SERVICE BULLETIN

Service Bulletin No. 475C
(Supersedes Service Bulletin No. 475B)
Engineering Aspects are
FAA Approved

SUBJECT: Crankshaft Gear Modification and Assembly Procedures

MODELS AFFECTED: All Lycoming direct drive piston aircraft engines (including VO-360 and IVO-360; excepting O-320-H, O-360-E, LO-360-E, TO-360-E, LTO-360-E, and TIO-541 series engines).

Figure 1. Details for Repairing Pilot Diameter of Crankshaft

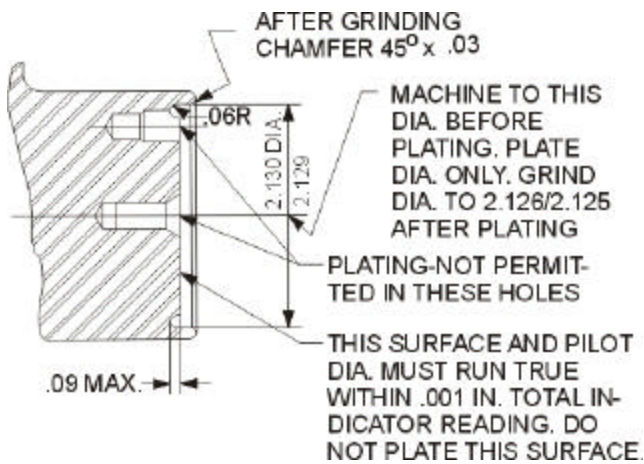
3. Check the pilot diameter of the counterbore on the end of the crankshaft for size and evidence of damage. This diameter should not exceed 2.1262 inches when measured at any location. If found to be oversize, the crankshaft may be repaired as described in the following steps. Do not attempt to reuse a crankshaft with an oversize pilot diameter.

- a. After removing the dowel, machine the pilot diameter in the end of the crankshaft to 2.129/2.130 inch as shown in the illustration. See Figure 1. Also, cut the .09 deep x .06R undercut as shown.

- b. Chrome or nickel plate the surface of the pilot diameter with a firmly bonded deposit that is free of pin holes, blisters and any other imperfections that could impair the function of the parts.

- c. After plating, stress relieve the shaft by baking at 390° to 410°F for 3 to 5 hours.
 - d. Grind the plated pilot diameter surface to 2.125/2.126 inch. Note that the diameter must run true with rear main journal within .001 inch total indicator reading.

- e. Chamfer edge of pilot diameter $45^\circ \times .03$ as shown in Figure 1.
4. If the dowel has been removed, check the condition of the dowel hole in the crankshaft. If out of round or oversize, ream as required for installation of an oversize dowel. Available oversize dowels and the corresponding size for reamed holes are shown in Table 1.
5. Install a new dowel in the crankshaft as shown in Figures 2 and 3. Insure that the correct dowel is installed.

Figure 2. Section Thru End of Crankshaft Showing Driven Height of STD-1065 Dowel

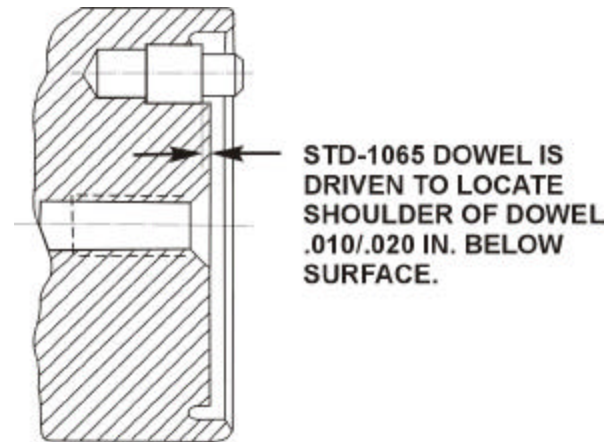
2. Check the condition of the dowel in the end of the crankshaft. It should be perfectly smooth with no indication of nicks or deformation. If it is out of round, it should be removed and replaced with a new one. Replacement instructions are in paragraph 4. If dowel condition is acceptable, insure that it is installed as shown in Figure 2 or 3.

Figure 5. Details for Rework of Crankshaft Gears to Current Configuration

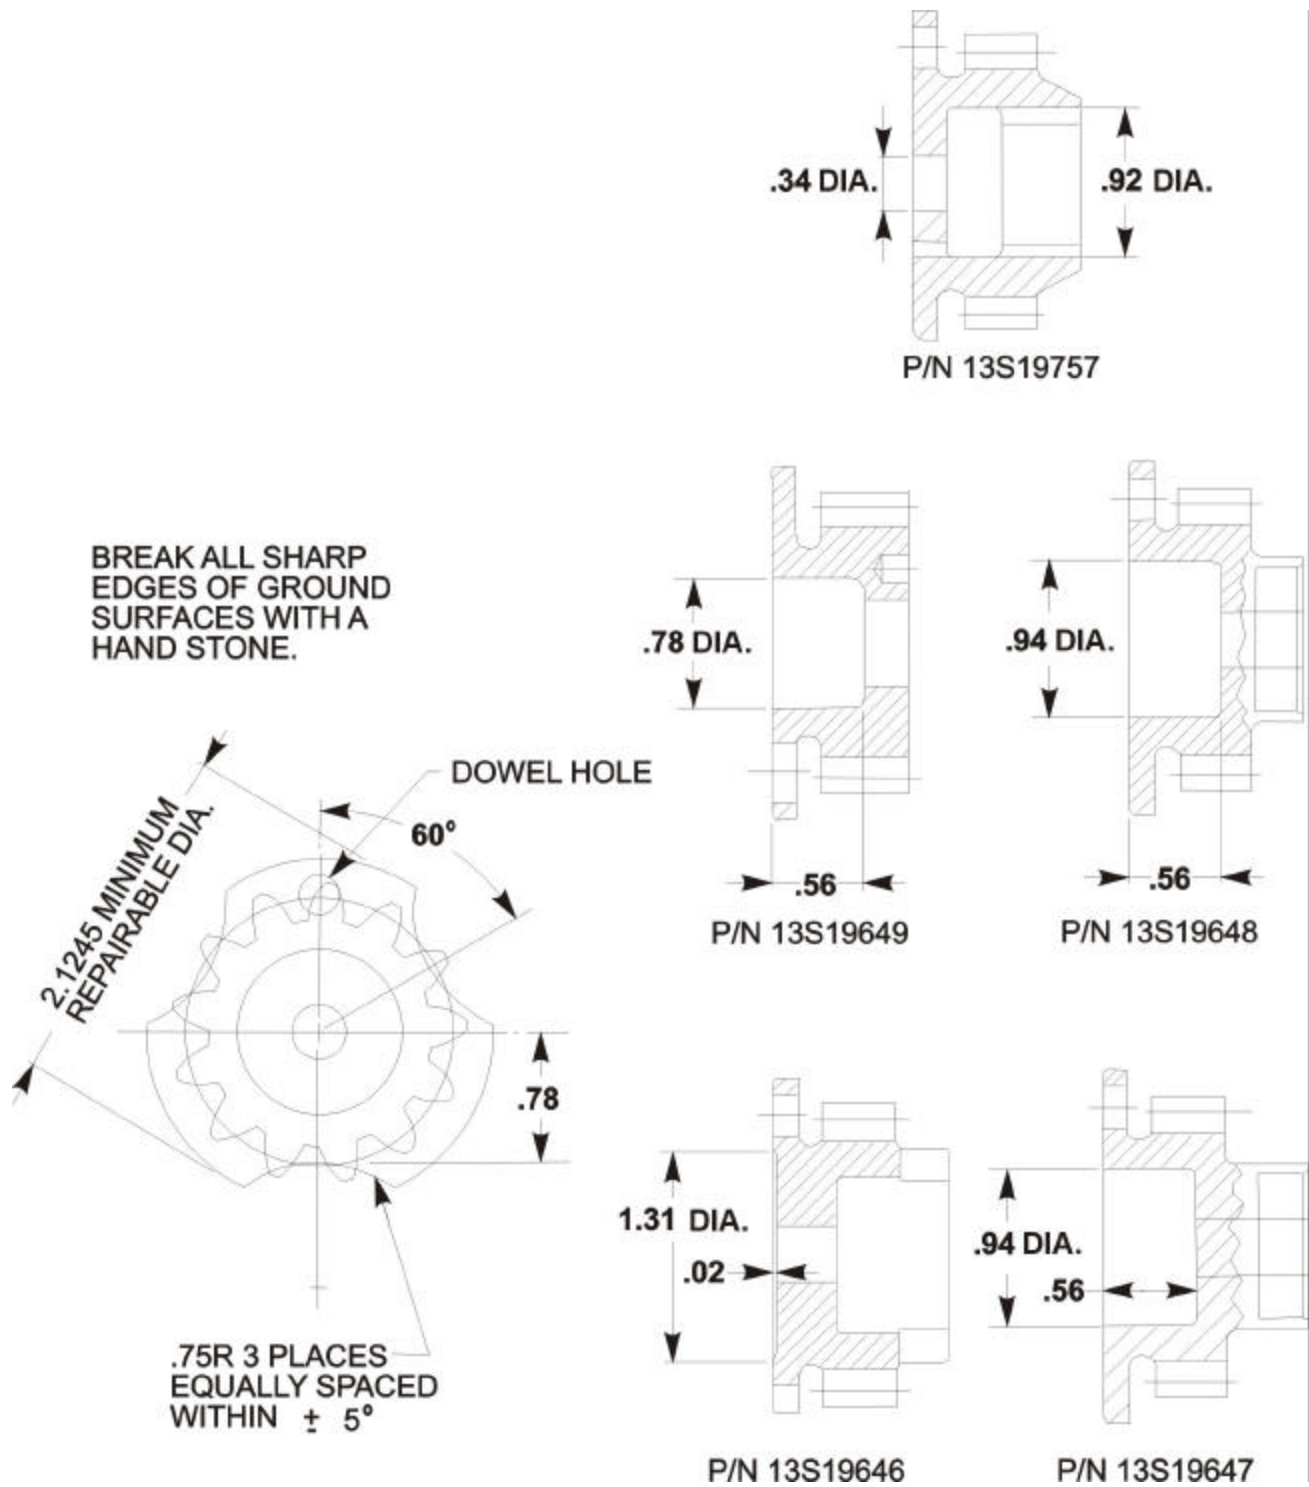
CRANKSHAFT GEARS FOR APPLICABLE ENGINES ARE NOW MANUFACTURED WITH THREE 3/4 INCH RADIUS SCALLOPS CUT INTO THE O.D. OF THE PILOT FLANGE AND A COUNTERBORE ON THE BACK SIDE OF THE GEAR. THESE ENLARGED SCALLOPS HAVE BEEN ADDED TO ALLOW INSPECTION OF THE GEAR AND CRANKSHAFT ASSEMBLY. SERVICEABLE GEARS MUST BE MODIFIED AS SHOWN IN FIGURE 5. PRIOR TO BEING REASSEMBLED ON THE CRANKSHAFT, OR A NEW GEAR THAT HAS BEEN MANUFACTURED TO THIS CONFIGURATION MUST BE INSTALLED. BEFORE MODIFYING THE GEAR, MEASURE THE DIAMETER OF THE PILOT FLANGE. IF IT IS LESS THAN 2.1245 INCH, IT SHOULD NOT BE RESUED. THE ORIGINAL 2.1250/2.1255 DIMENSION OF THE CRANKSHAFT GEAR MUST BE RESTORED WITH A FLASH COPPER PLATE OF UP TO .0005 INCH MAX.

NOTE: Revision “C” revises Table 2 and Figure 5.

Figure 6. Rear End View of Crankshaft Showing Associated Parts

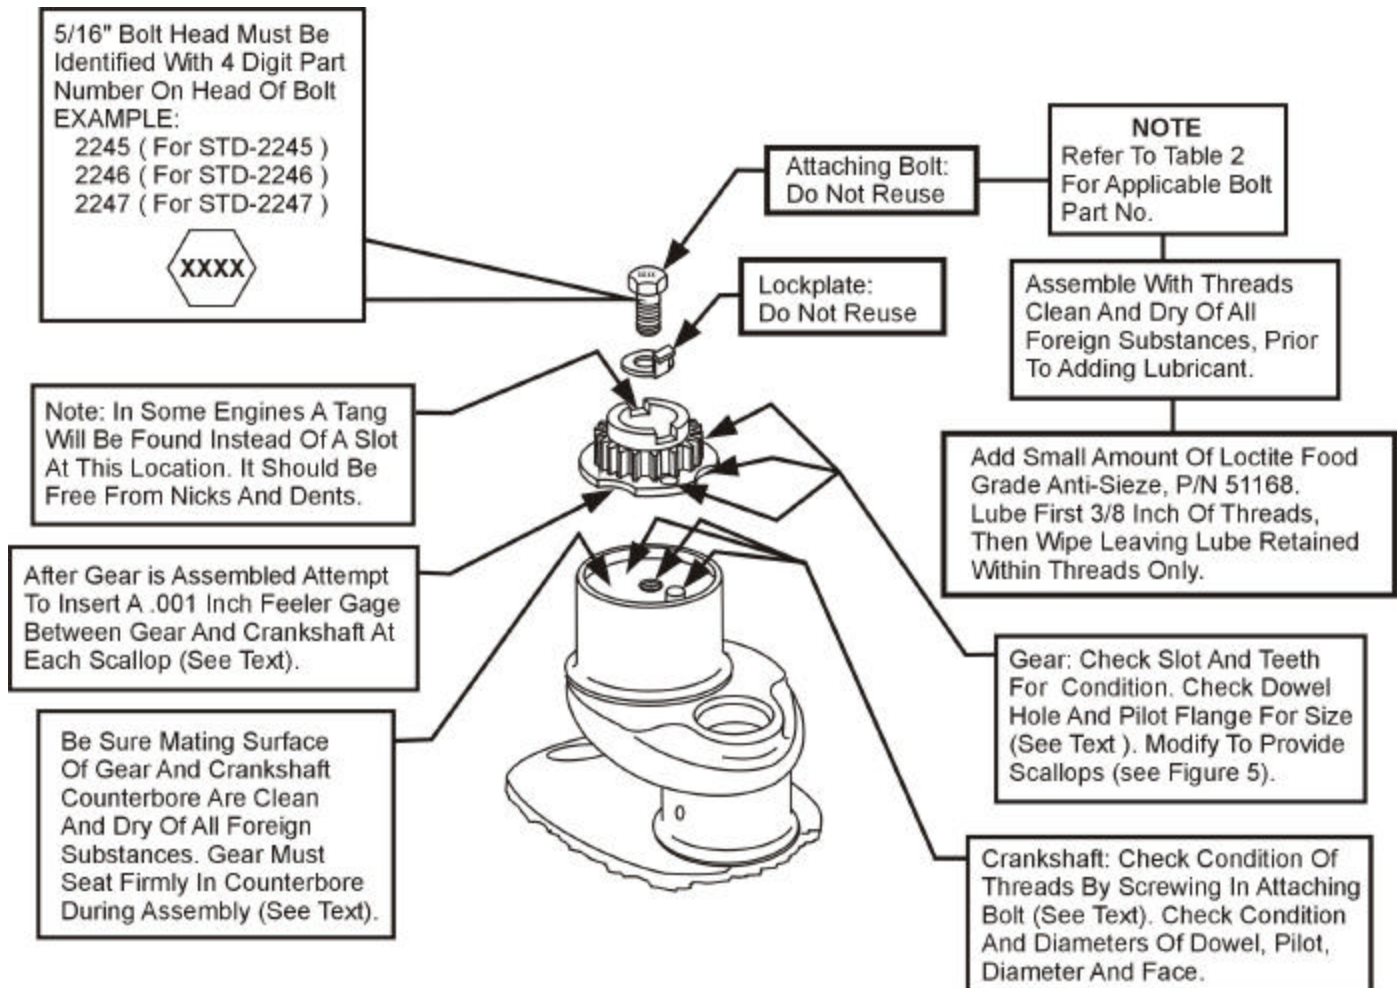
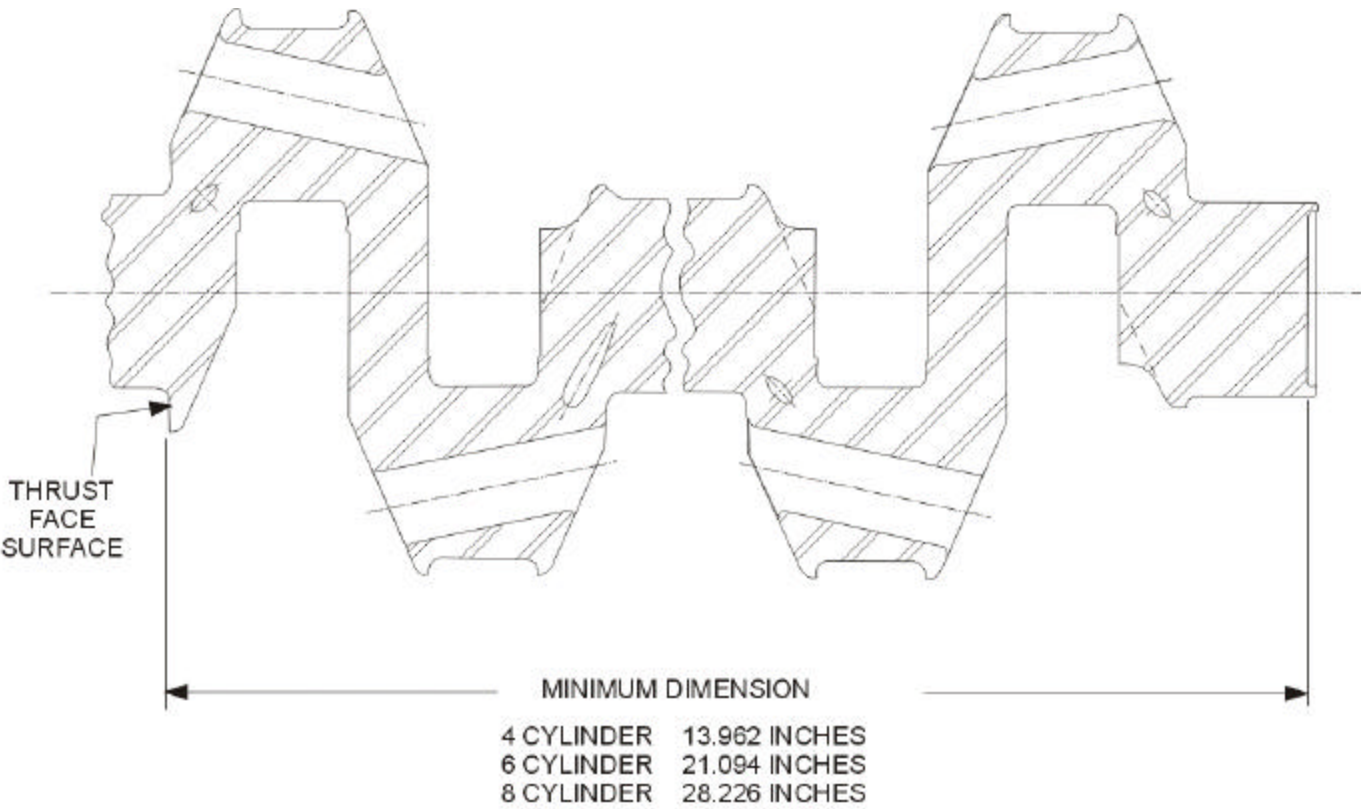
- Assemble the gear to the crankshaft **using both a new lockplate and bolt**. Refer to Figure 6. The correct bolt, lockplate and dowel for each gear are shown in Table 2. Tighten the bolt to 125 in.-lbs. torque, then with a hammer and brass drift, tap lightly around the pilot flange of the gear and listen for sharp solid sounds from the hammer blows that would indicate that the gear is seated against the crankshaft. As a check on the seating against the crankshaft, attempt to insert a pointed .001 inch thick feeler gage or shim stock between the gear and crankshaft at each of the three scallops. The .001 feeler gage, or any smaller feeler gage, must **NOT** fit between the two surfaces at any location. (.001 feeler gage is used as an indicator, however, there must be no clearance between crankshaft and gear.) Retighten the gear attaching bolt to the proper torque. Tighten the 5/16 inch bolt to 204 in.-lbs. torque or the 1/2 inch bolt to 660 in.-lbs. torque. Measure the clearance between the O.D. of the gear flange and the pilot I.D. of the crankshaft. There should not be more than .0005 inch clearance at any point.
